NUMBER: M20-43

SUBJECT: **STATIC PRESSURE SYSTEM MODIFICATION TO
ELIMINATE MOISTURE ACCUMULATION IN SYSTEM**

AFFECTED: All M20 Series models and serial numbers prior to:
M20C - S/N 20-1257
M20J - S/N 24-0787
M20K - S/N 25-0101

FIGURE 1

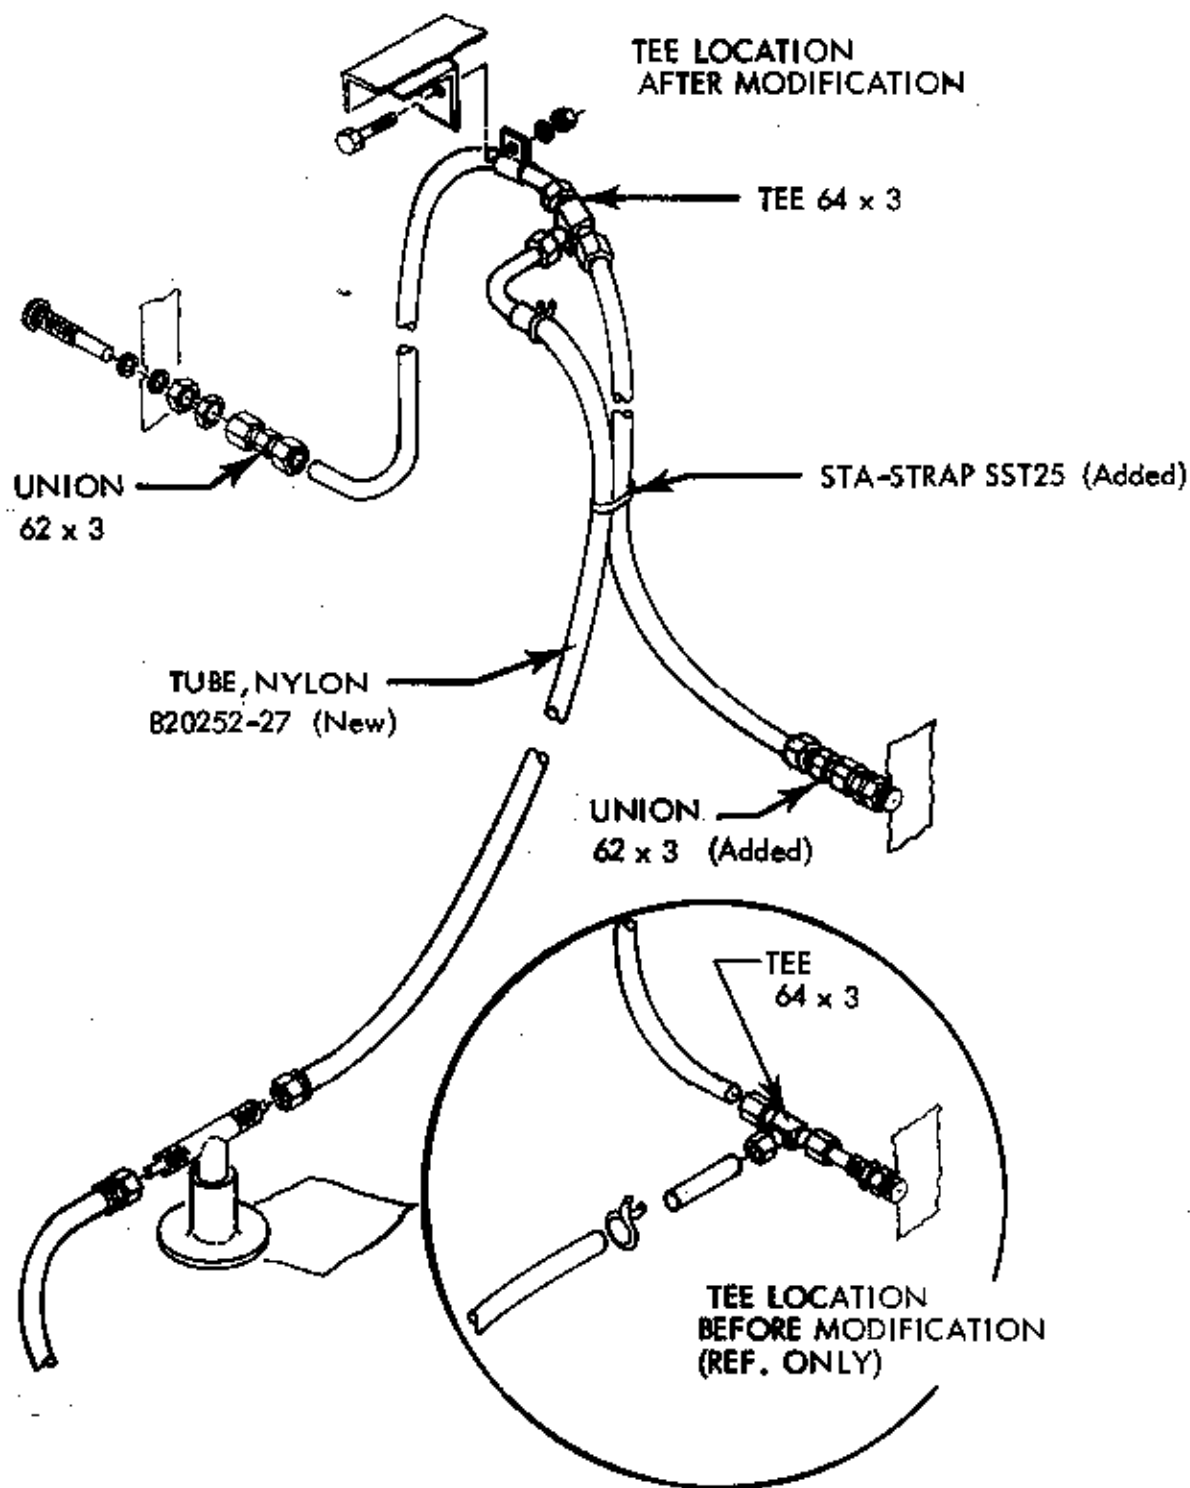
Certain environmental conditions may cause moisture to accumulate within the static pressure system. This accumulation of moisture can cause false altitude, vertical speed and airspeed indications to the pilot. It is recommended that the static pressure system be modified as described in this Service Instruction.

1) Remove static system tube assembly connected to static port buttons located on both sides of the tailcone assembly. Remove tube from clamp on longeron located at top of tailcone assembly. Remove the nylon tube from the drain valve located on bottom skin of tailcone assembly. The antenna wire clamp must be loosened from nylon tube prior to removal. Slide through bulkheads on older models.

2) Disassemble 64 X 3 tee from tube assembly leaving nuts and ferrules on tube end and on static button tube end. Tag this end of tube before removal of tee for a dimension to be addressed later.

3) Lay the long tube assembly on flat surface and measure along center line of tube, starting from opposite end of tube where the 64 X 3 tee was connected, 23.5 inches and cut tube in two with tube cutter. Deburr both ends tubes now cut and clear filings from tubes.

- 4) Lay short tube on flat surface and bend a 90° angle in tube so each leg is equal in length. Use a bend radius of approximately 1 inch while bending being careful not to collapse tube walls.

- 5) Install 64 X 3 tee between the two cut sections of old tube assy using the nuts and ferrules from the 62 X 3 union supplied in the kit at this new tee location. The tee must be located in a horizontal plane, when installed on aircraft, with third leg facing forward to accept new aluminum and nylon tubes. Connect the short aluminum tube to tee with tube leg pointing toward left side of aircraft. Connect nylon tube, included in kit, to this leg of tube using the spring clamp removed from old installation. Clamp nylon tube to adjacent section of aluminum tube attached to static button, with the SST25 sta-strap included in the kit.

- 6) Completed assembly is now ready to install onto aircraft. Connect the assembly to the 62 X 3 union already connected to right hand side of aircraft and using the new 62 X 3 union supplied in kit, connect the assembly to the static button on the left side of the aircraft using the old nuts and ferrules already attached. Reconnect the clamp at the top of the tailcone assy and the antenna wire clamp at their existing locations. Connect the nylon tube to the static drain valve finger tight plus 1/4 turn. Tighten all nuts at the new connections to a torque of 15-20 inch pounds. Do not over tighten, damage to ferrules or tube may result.
